# **IAEA Review of Safety Related Aspects of Handling ALPS Treated Water at TEPCO's Fukushima Daiichi Nuclear Power Station**

**Report 3: Third Review Mission to Japan after the Start  
of ALPS Treated Water Discharge (December 2024)**

Figure 2: Tritium activity concentrations in seawater as a function of distance from the discharge outlet (darker colours indicate more measurements; regional long-term background indicated by the grey area)

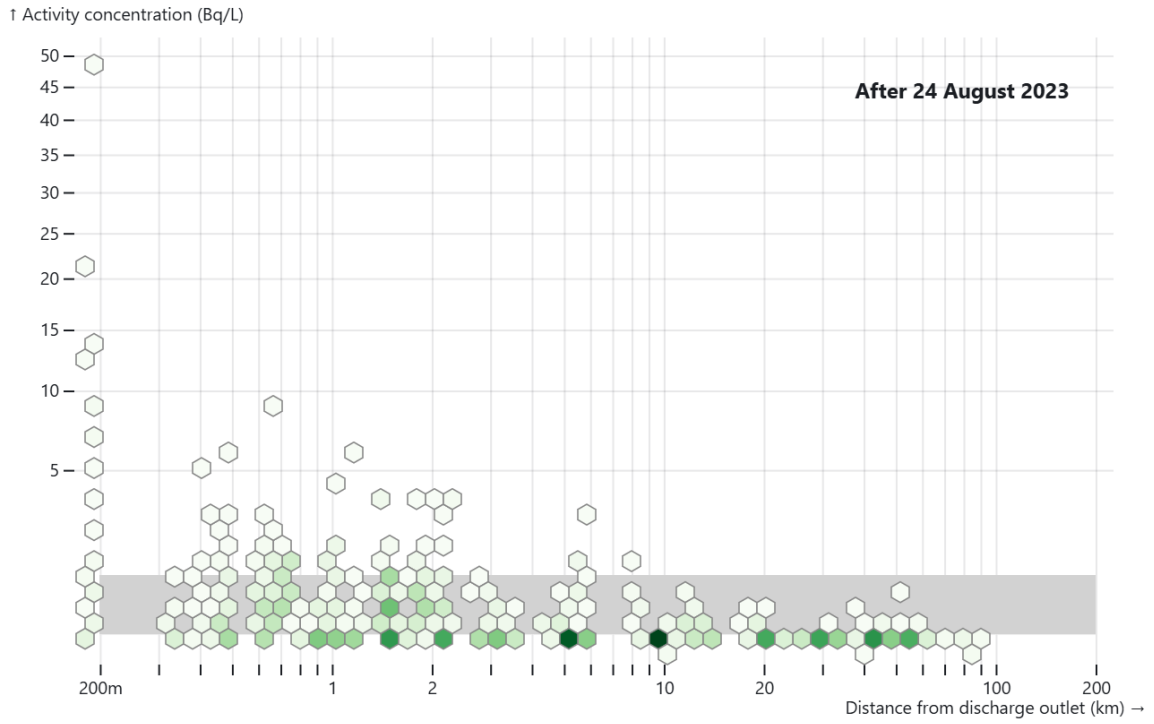
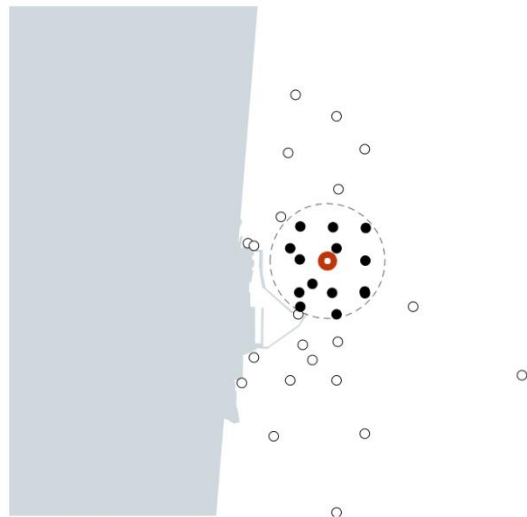
The Task Force noted that TEPCO's presentation of tritium results in seawater can be enhanced to avoid created confusion by combining data obtained through methods with significantly different detection limits. Given the distinct purposes of the daily quick measurements (detection limit of 10 Bq/L) and the less frequent, more sensitive analyses (detection limits of 0.1 Bq/L (electrolytic method) and 0.4 Bq/L (Distillation method)) conducted weekly or monthly, these results should be presented separately with clear explanations of their respective objectives and limitations. The Task Force further observed that even within the category of sensitive weekly measurements, the varying detection limits between 0.1

and 0.4 Bq/L introduced additional complexity for data interpretation. For presentations to scientific audiences, the Task Force recommended that all monitoring data within the CRMP should consistently include three key parameters: the measured activity concentration, the associated measurement uncertainty, and the method detection limit. The Task Force acknowledged that TEPCO already implements this comprehensive approach for source monitoring results, commended the practice and encouraged for all environmental monitoring presentations.
